From: Melton, Mark (ECY)
Sent: Tuesday, November 7, 2023 4:53 PM
To: Greg Steindorf
Cc: Heye, Amanda (ECY)
Subject: RE: Wetland Mitigation Downstream Distance

From: Greg Steindorf <gsteindorf@recivil.com>
Sent: Thursday, November 2, 2023 1:25 PM
To: Melton, Mark (ECY) <mmel461@ECY.WA.GOV>
Cc: Paul Knippel <PaulKnippel@cityofferndale.org>; Dale Buys <dale@recivil.com>; Labib, Foroozan (ECY) <flab461@ECY.WA.GOV>
Subject: RE: Wetland Mitigation Downstream Distance

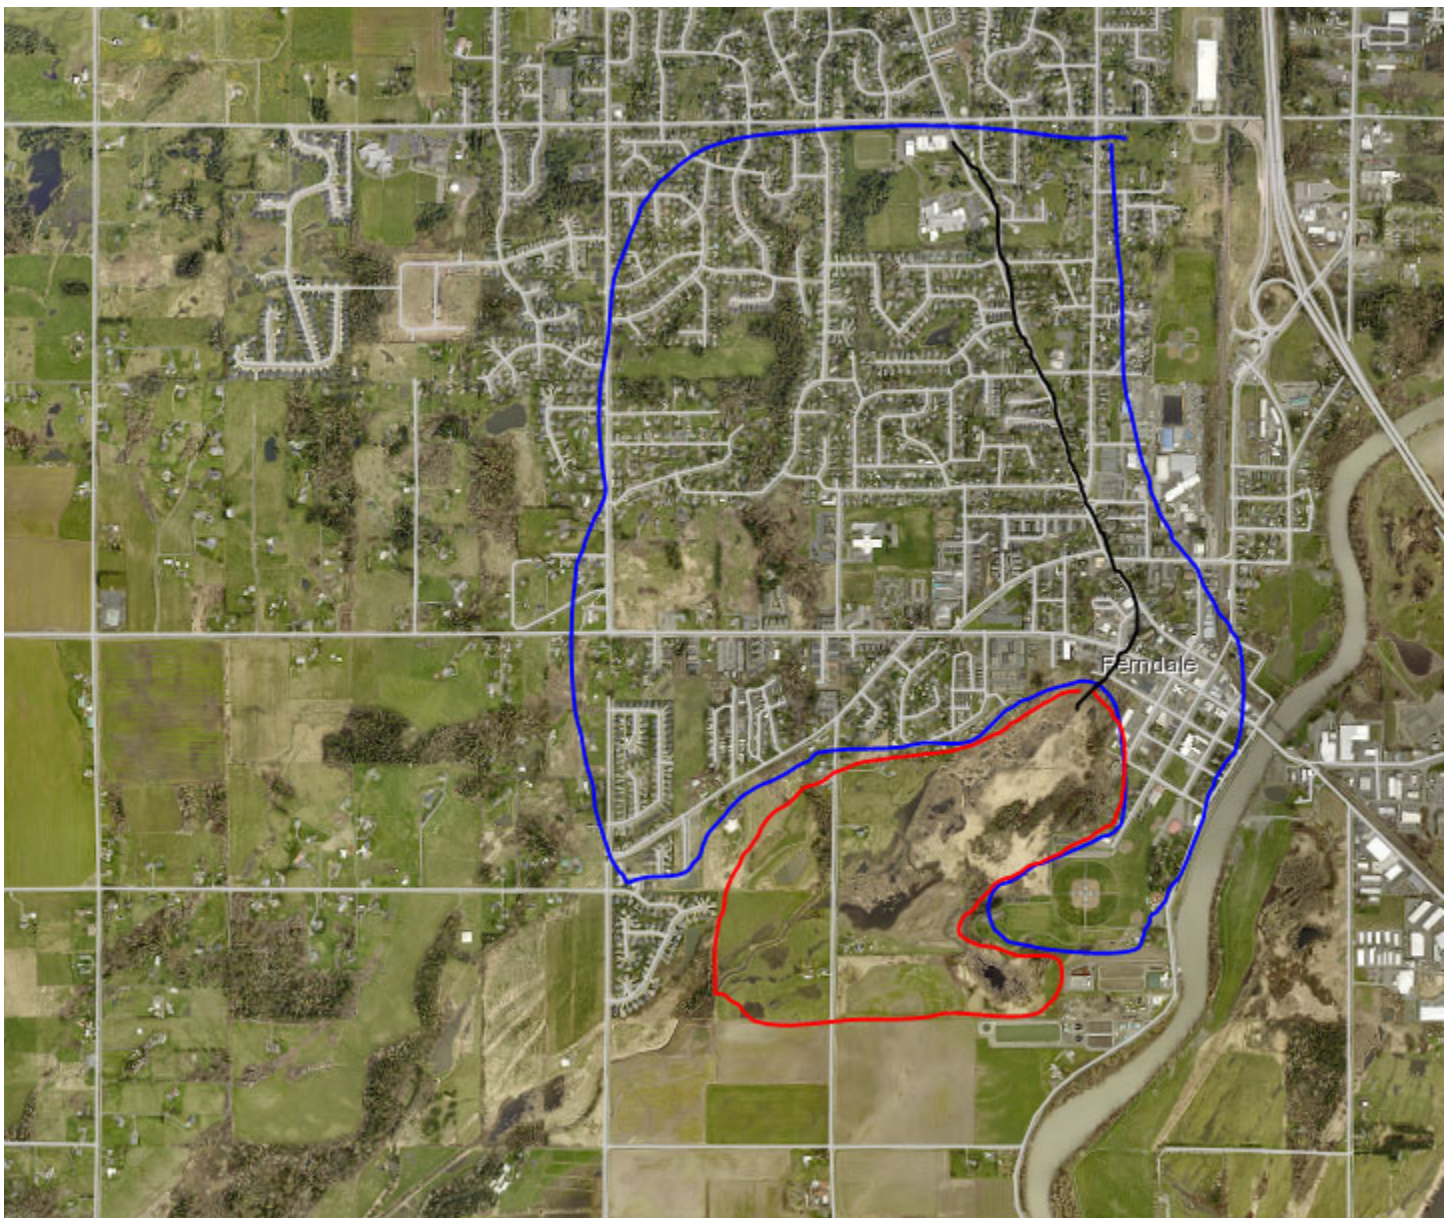
I do most of the stormwater review for the private developments in Ferndale so I am anticipating I will run into this several times. In the image below, the approximate wetland boundary is circled in red, the approximate contributing basin is circled in blue, and the black line is a flow path to the wetland that is approximately 1.2 miles long. I am not looking for site specific design guidance but considering the size of the contributing basin and the potential for numerous projects that currently contribute to the wetland, I would like to know what Ecology's opinion is on how detailed a small or large project in this area needs to get to address their potential wetland impacts? The City (Paul Cc'd here) and I are wanting to provide consistent guidance to all design engineers that may submit a project within this large contributing basin and we want to make sure we are following the manual as Ecology is intending for this requirement.

For the distance question you asked about, the answer comes from determining what the receiving water is. In the scenario that you provided if the 1.2 mile flow path is conveyance piping that outfalls at a wetland then MR8 would apply. If the 1.2 mile flow path is actually a river then the project would be outfalling to the river

and that would be the receiving water, not the wetland. In other words there is not a cutoff distance if the wetland is determined to be the receiving water.

For the question about modeling the 50 flow control BMPs. Our expectation is that the modeling for the flow control BMPs is focused on the BMPs within the project area not the entire contributing basin.
